Agenda
Canmore Planning Commission
Canmore Civic Centre – Council Chambers
Wednesday, July 5, 2023, at 2:00 p.m.

DATE:	JULY 5, 2023
PROPOSED DEVELOPMENT:	SITE AND BUILDING AMENDMENTS TO PL20210301
APPLICATION NUMBER:	PL20230138
LEGAL DESCRIPTION:	LOT 8, BLOCK 7, PLAN 9512298
CIVIC ADDRESS:	121 BOW MEADOWS CRESCENT
CURRENT USE(S):	UNDER PL20210301, APPROVED FOR A MIXED-USE BUILDING WITH 24 UNITS: <ul style="list-style-type: none">• EMPLOYEE HOUSING (12 UNITS)• WAREHOUSE (6 UNITS)• CONTRACTOR SERVICE AND REPAIR (4 UNITS)• LIGHT MANUFACTURING (2 UNITS)
APPLICANT:	LEA LOHNES, MONTANE ARCHITECTURE
REFERENCED DOCUMENTS:	LAND USE BYLAW 2018-22: <ul style="list-style-type: none">• 5.3 IND 2 GENERAL INDUSTRIAL DISTRICT

This application proposes site and building amendments to PL20210301, a mixed-use development, including employee housing, that was approved by the Canmore Planning Commission (CPC) on May 25, 2022. The subject site is located at 121 Bow Meadows Crescent. Development at the site has not yet commenced.

1 SITE PLAN - PARKING
1 : 100

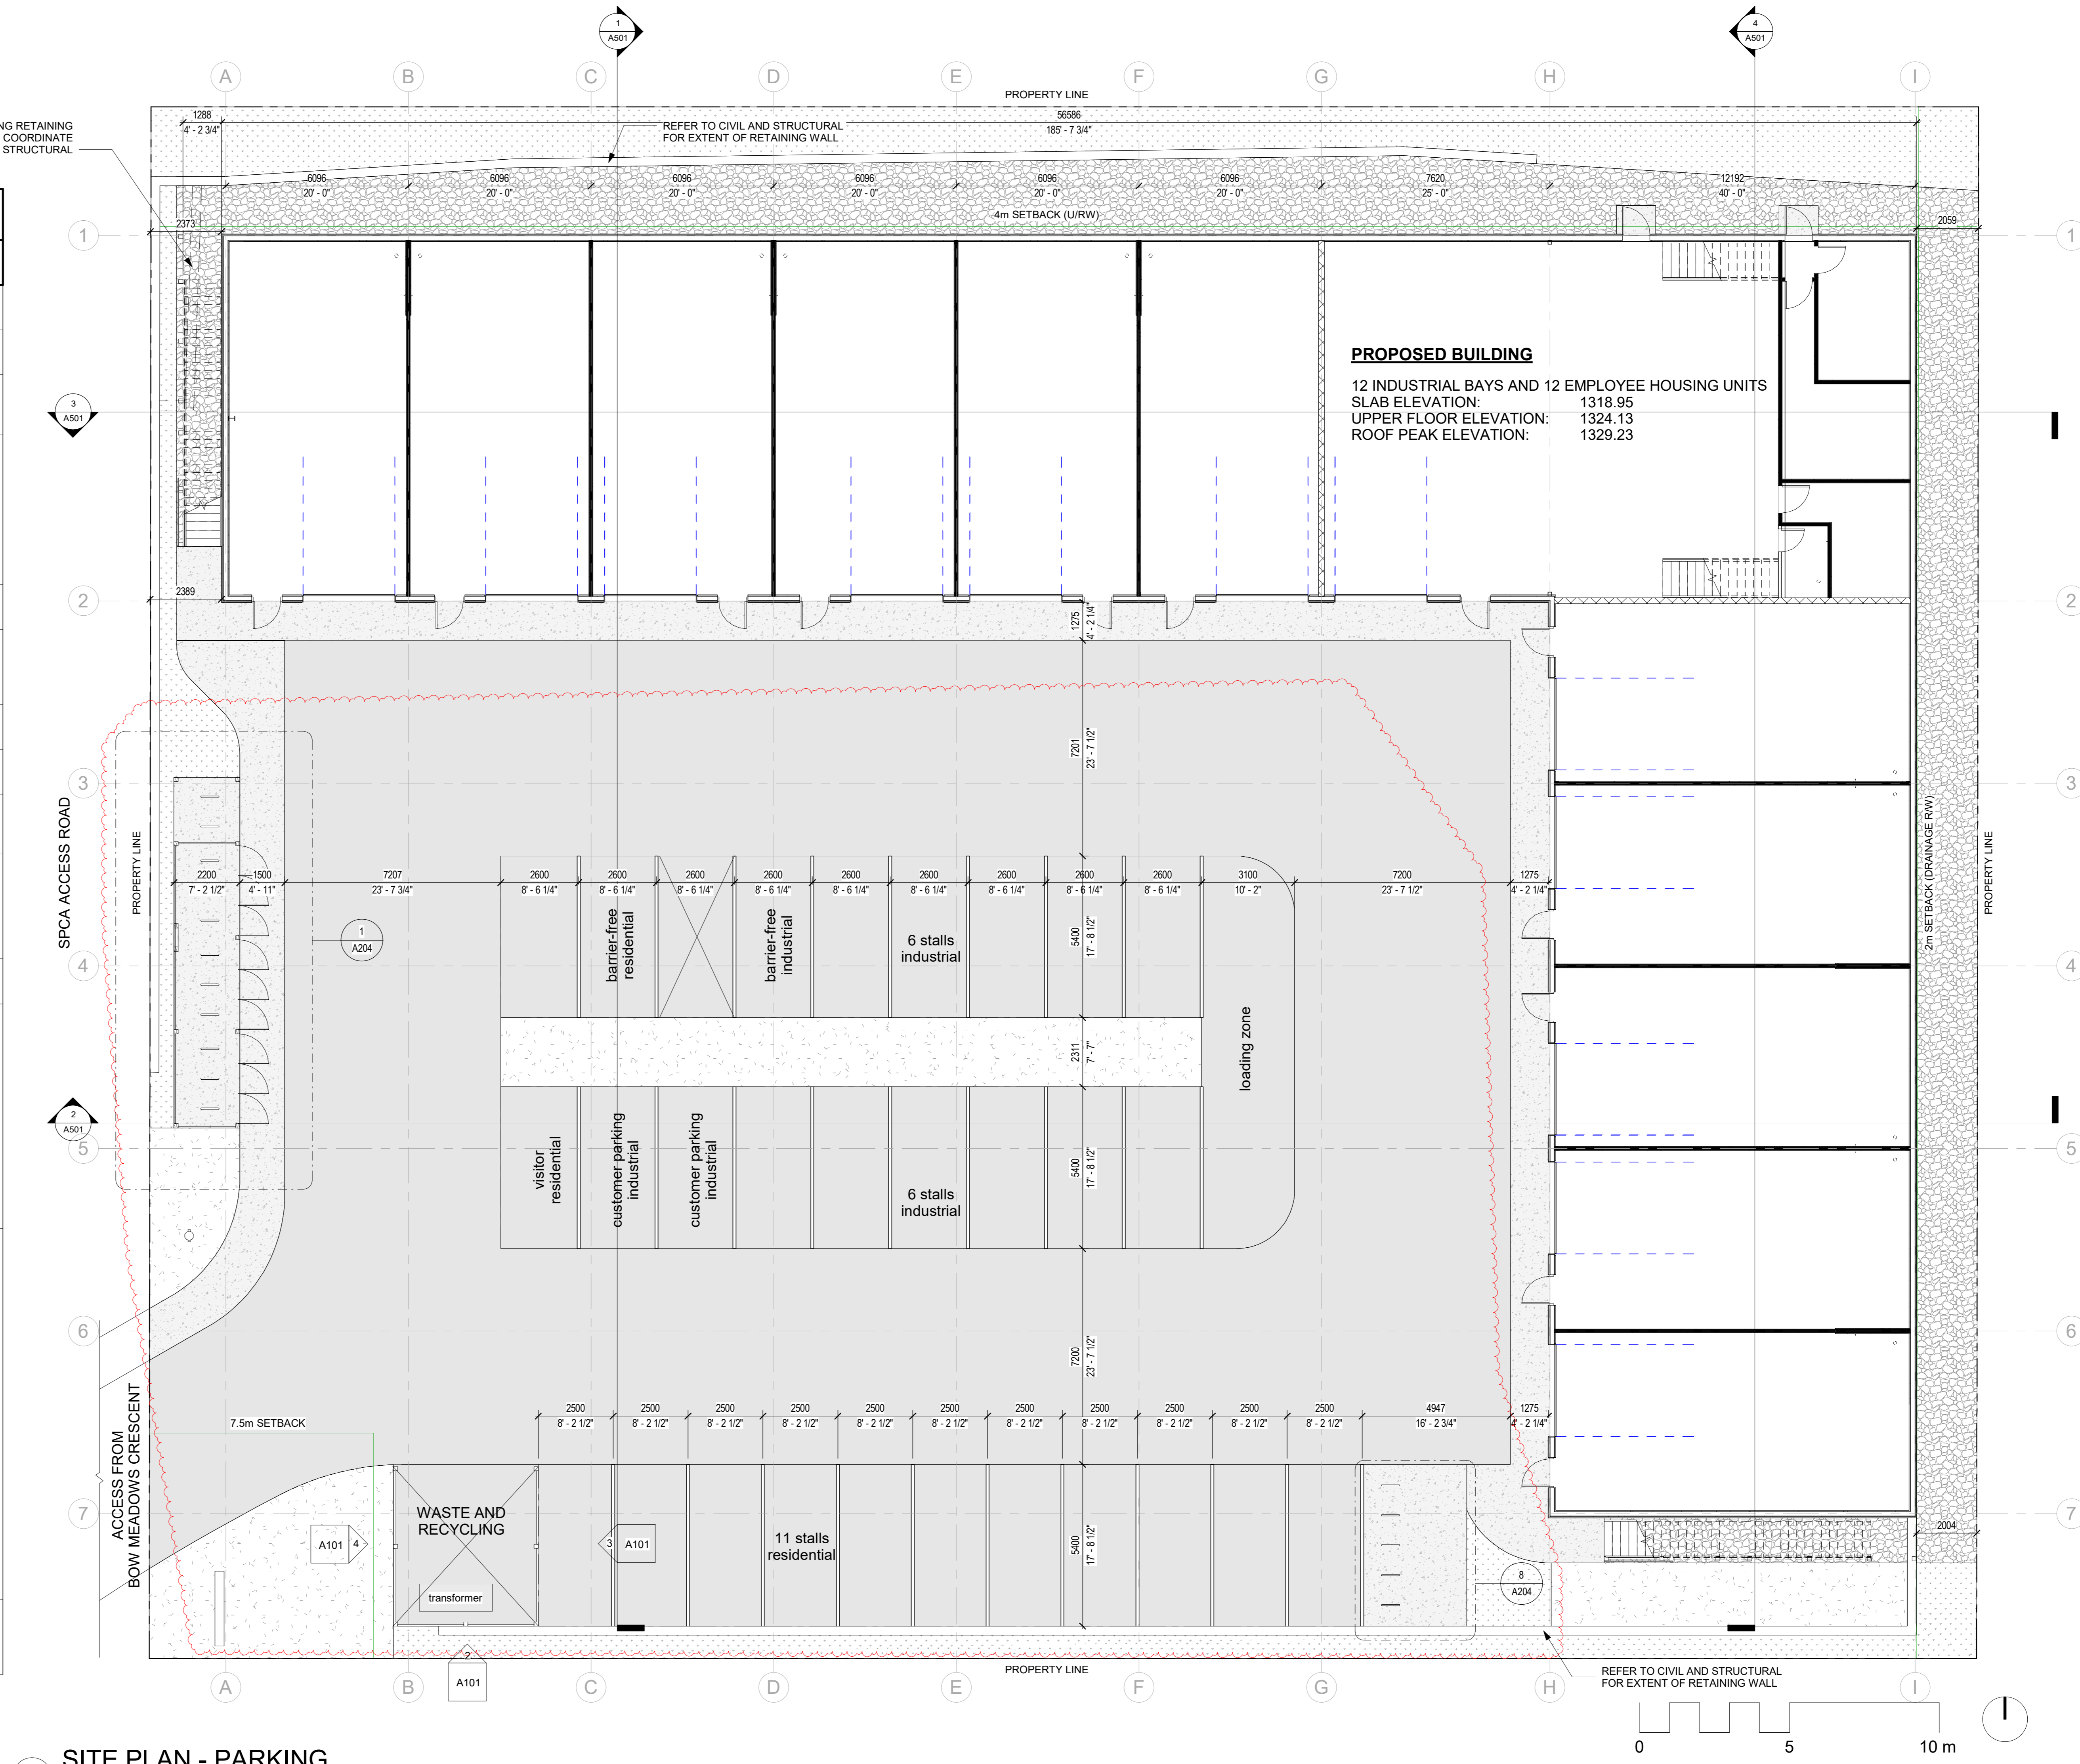
- a. Site Changes
 - a. The on-site vehicle parking has been increased and reconfigured (from 22 stalls to 28 stalls)
 - b. The screened waste area has been moved closer to the front property line
 - c. A landscaping bed has been created in the centre of the parking lot
 - d. Long-term and short-term bicycle parking has been reconfigured
 - e. A picnic table has been added
- b. Architectural Changes
 - a. The building's exterior colours have been changed from cream colour to grey and timber colours.
 - b. A large portion of the building's exterior materials have been changed from basic metal to faux wood metal
 - c. A loft has been added to Bay 7 (an industrial bay located on the main floor)
 - d. The design of the roof has been altered (see north-east corner)

- b. Updates to so consistency with the Site Plan or should the Plot Plan be accurate, an updated Site Plan shall be provided.
7. **Prior to the release of the development permit, the applicant shall provide** confirmation that they have provided Fortis with their plans for the existing retaining wall in the URW.

PLOT PLAN

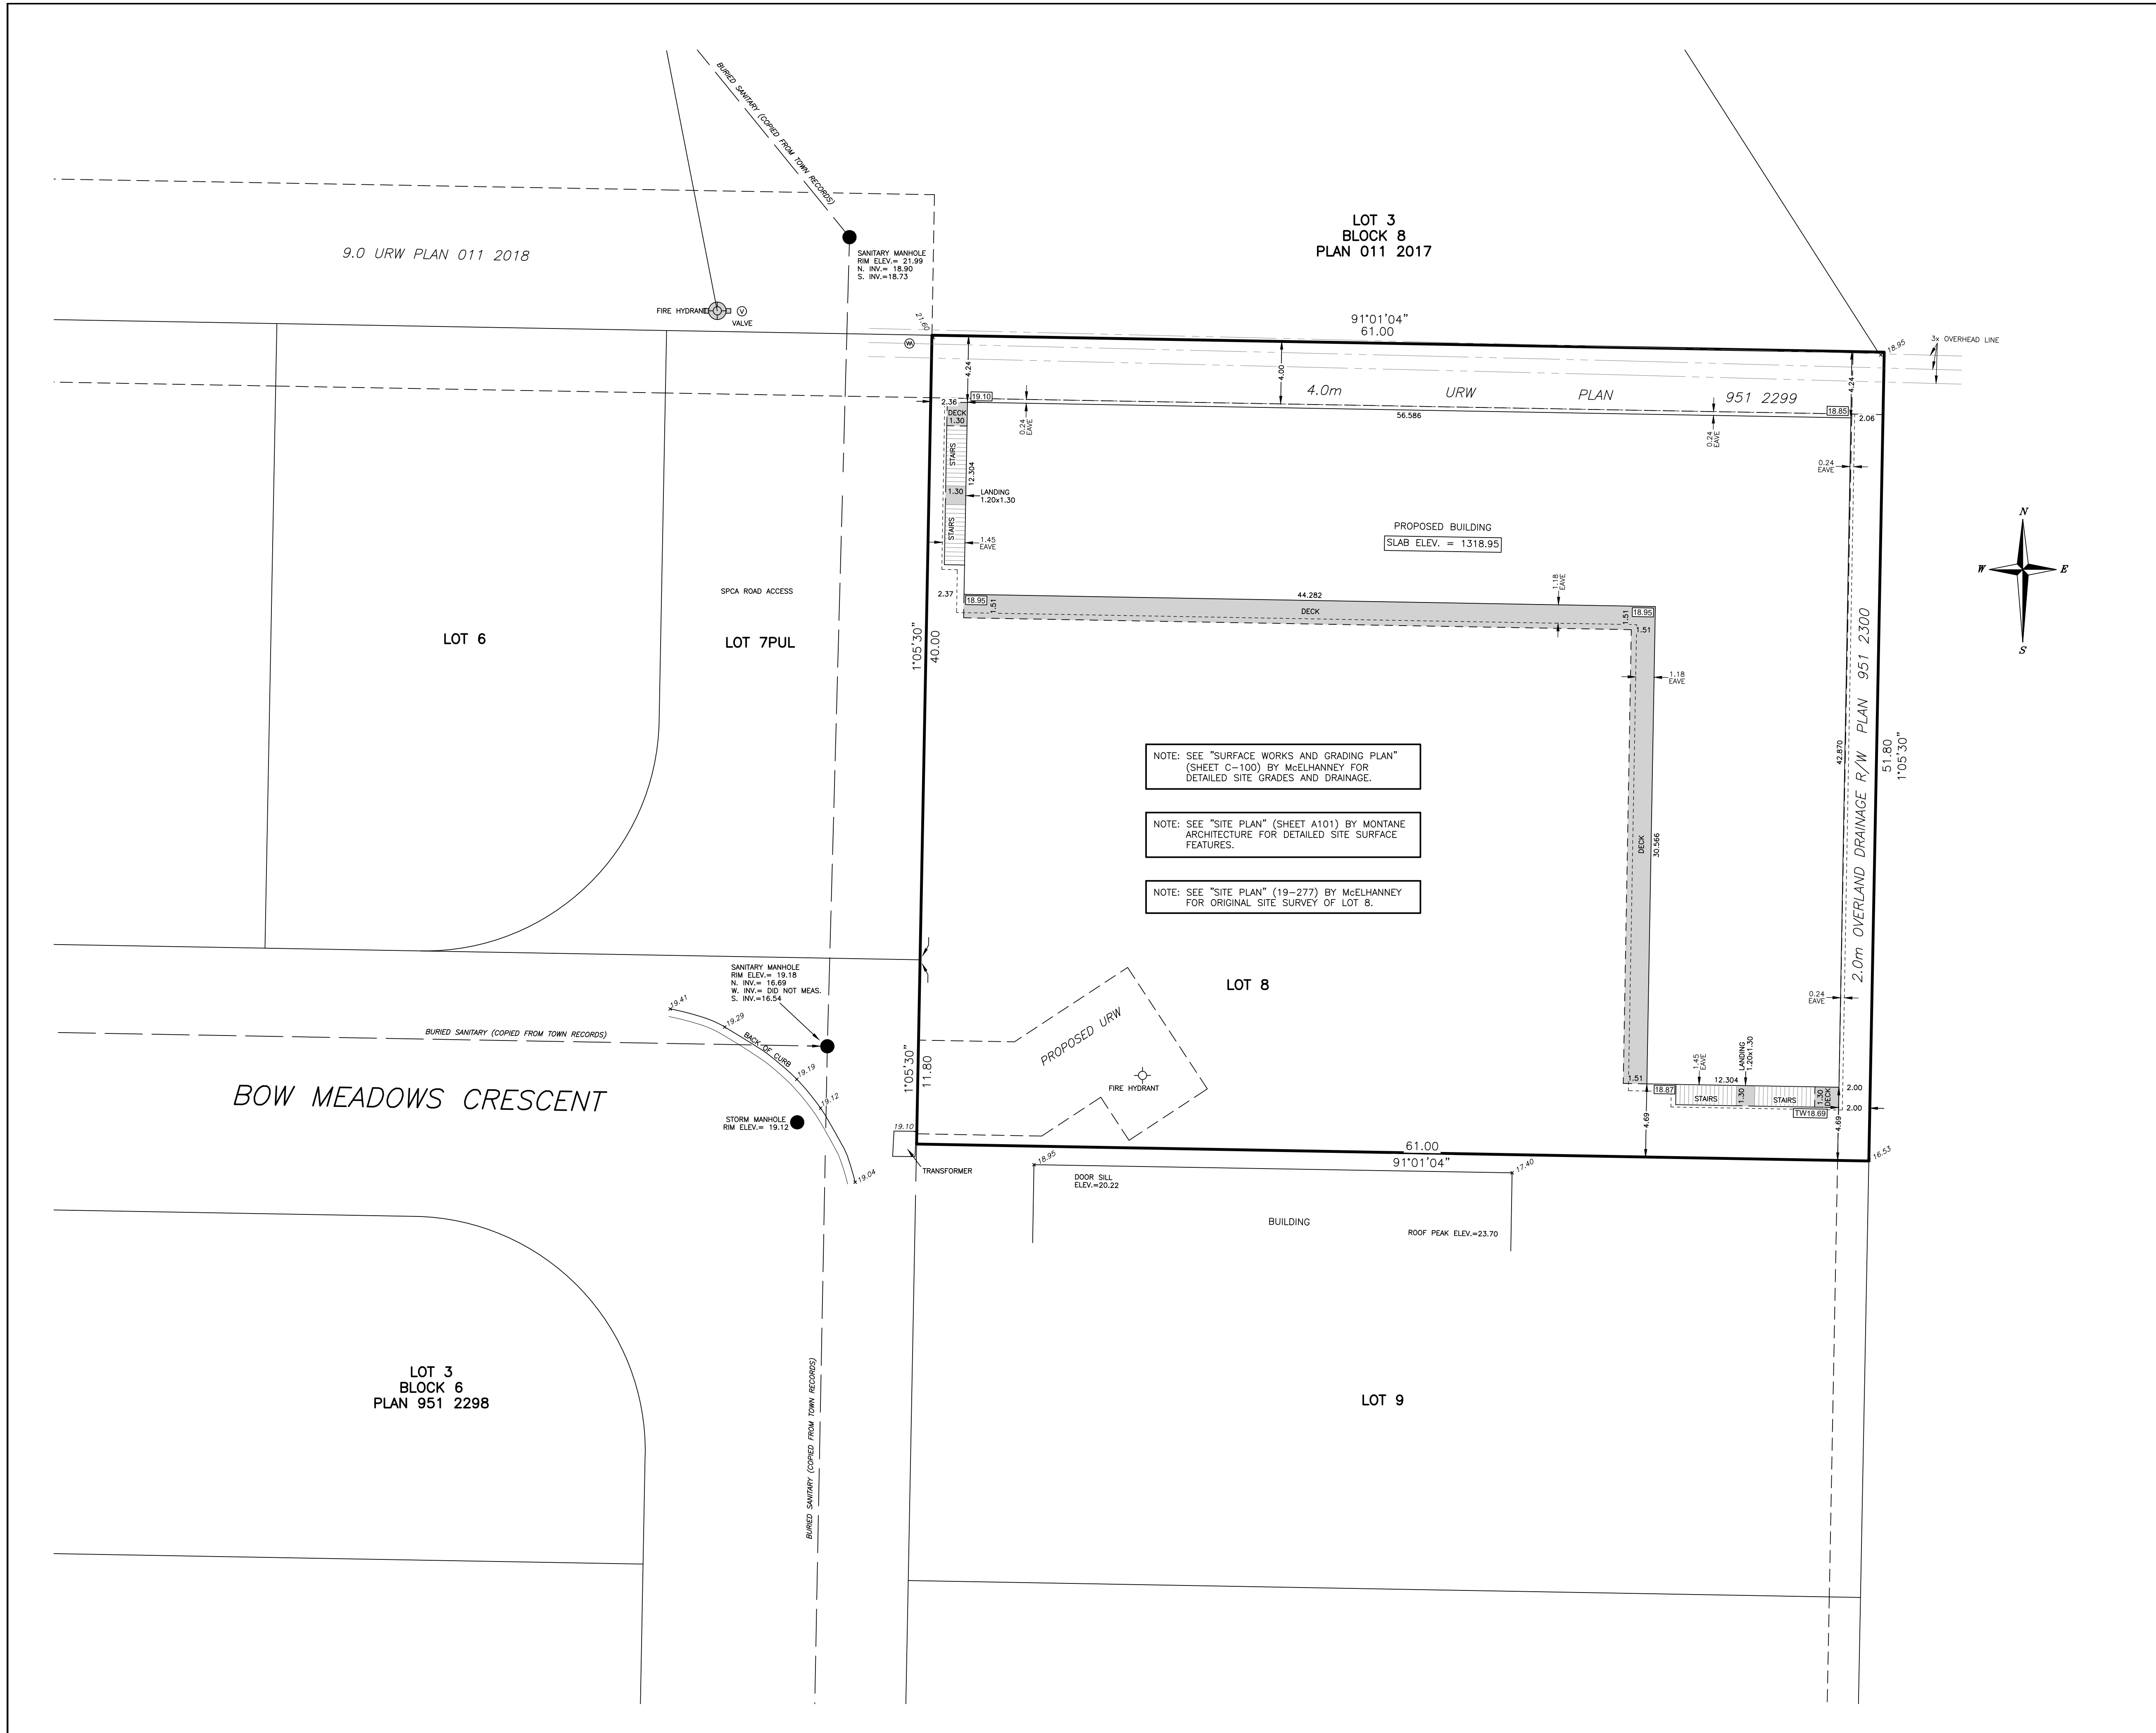
6. **Prior to the release of the development permit**, the applicant shall provide an updated Plot Plan addressing the following:
 - a. Relocation of the fire hydrant that appears to be in a parking stall
